Access Compliance Report

Public Rights-of-Way

(Curb Ramps)

Intersection ID: N/A	Main Street: ARBOR_LOOP_DR	Cross Street: CITY_PARK_DR	Location: SE
ADA ID: CBD606C7DC77	Ramp Type: Perp	Initial Pass/Fail: Fail	Overall Compliance: No
Severity Score: 1.25			
Codes/Mitigation Info/Possible Solution		Field Measurements/Component Compliance

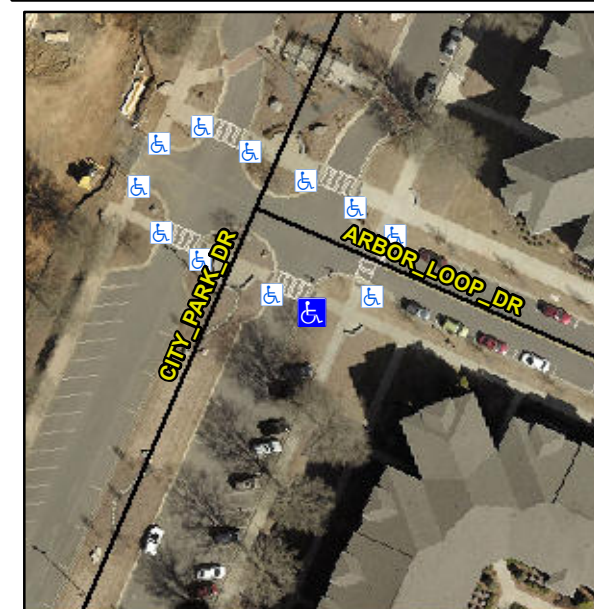
Not Found, R304.5.3

Compliance	Description	Data	Compliance	Description	Data
N/A	Ramp Length (in)	80.0	Yes	Ramp Slope (%)	5.4
Yes	Ramp Width (in)	70.0	No	Ramp XSlope (%)	2.3
N/A	Flare Type LT	N/A	N/A	Flare Type RT	N/A
N/A	Flare Slope LT (%)	N/A	N/A	Flare Slope RT (%)	N/A
N/A	Flare Traversable LT?	N/A	N/A	Flare Traversable RT?	N/A
N/A	Landing Length (in)	N/A	N/A	DWS Provided?	N/A
N/A	Landing Width (in)	N/A	N/A	DWS Contrast?	N/A
N/A	Landing Slope (%)	N/A	N/A	DWS Length (in)	N/A
N/A	Landing X Slope (%)	N/A	N/A	DWS Full Width?	N/A
N/A	Landing Curb? (Y/N)	N/A	N/A	DWS Offset (in)	N/A
N/A	Shared Landing?	N/A			
N/A	Gutter Ponding?	N/A	N/A	Gutter Slope (%)	N/A
N/A	Gutter Lip Ht (in)	N/A	N/A	Gutter X Slope (%)	N/A
N/A	Painted X Walk1?	Yes	N/A	Painted X Walk2?	N/A
	X Walk 1 Direction	To NW		X Walk 2 Direction	N/A
N/A	X Walk 1 Width (in)	111.0	N/A	X Walk 2 Width (in)	N/A
	X Walk 1 Slope (%)	1.9		X Walk 2 Slope (%)	N/A
	X Walk 1 X Slope (%)	4.5		X Walk 2 X Slope (%)	N/A

Remove & Replace Entire Ramp.
